**Re: Request for review of the request for issuance for the CDM project activity  
'No.2 HFC23 Decomposition Project of Zhejiang Juhua Co., Ltd, P. R. China'  
(Ref. No. 0868)**

Zhejiang Juhua Co., Ltd has been informed that the request for issuance for the second periodic verification for No.2 HFC23 Decomposition Project of Zhejiang Juhua Co., Ltd, P. R. China is under consideration for review because three requests for review have been received from three members of EB.

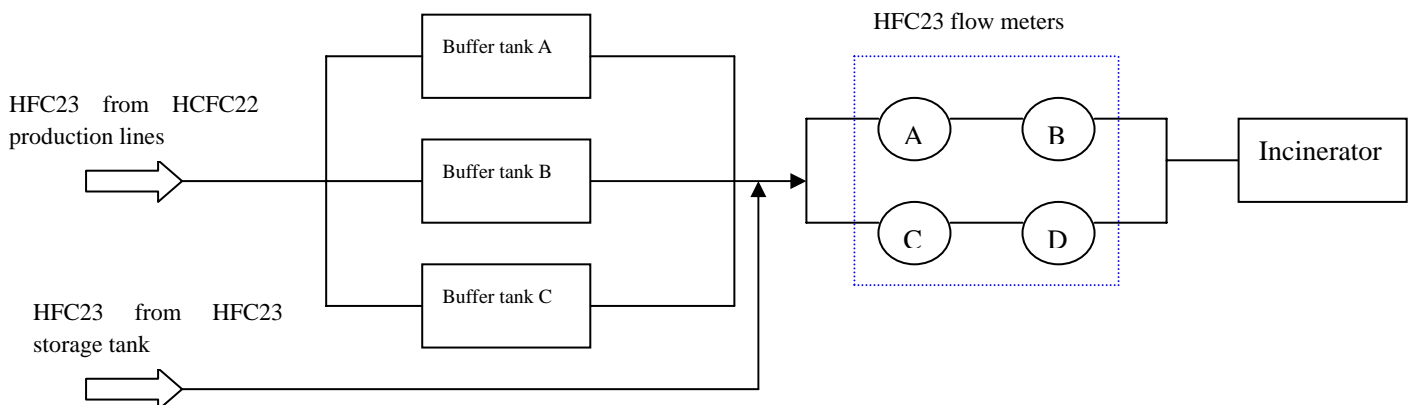
The monitoring report (page 4) stated that "HFC23 waste gas generated in ...is sent to these three HFC23 buffer tanks, after measured by HFC23 flow meters, and then those HFC23 enter into the incinerator to be decomposed." Further clarification is required on how the quantity of HFC23 supplied to the destruction process was measured.

In monitoring report (page 4) stated that "In this project, there are three HFC23 buffer tanks. HFC23 waste gas generated in No.703 and No.4-703 HCFC22 production lines is sent to these three HFC23 buffer tanks, after measured by HFC23 flow meters, and then those HFC23 enter into the incinerator to be decomposed." The above description is not very clear, the correct one should be "In this project, there are three HFC23 buffer tanks. The HFC23 waste gas generated in No.703 and No.4-703 HCFC22 production lines is sent to these three HFC23 buffer tanks first, then HFC23 waste gas will be measured by HFC23 flow meters and finally send to the destruction process."

The following is the more detailed description:

In this project, there are three buffer tanks (gas phase tank) .The purpose of buffer tanks is to buffer against the HFC23 generated from No.703 and No.4-703 HCFC22 product lines. When the incinerator shutting down, the HFC23 generated from these HCFC22 product lines would be stored temporarily in these buffer tanks, and be destroyed after incinerator is put into operation again. In normal circumstance, those buffer tanks are not used to store HFC23 generated from No.703 and No.4-703 HCFC22 production lines, their function is only to buffer against the HFC23. These three buffer tanks (gas phase tank) were installed before HFC23 flow meters (i.e. flow meters measuring the quantity of HFC23 supplied to the destruction process).

The location relationship between those buffer tanks and the flow meters used to measure the quantity of HFC23 supplied to the destruction process is shown below:
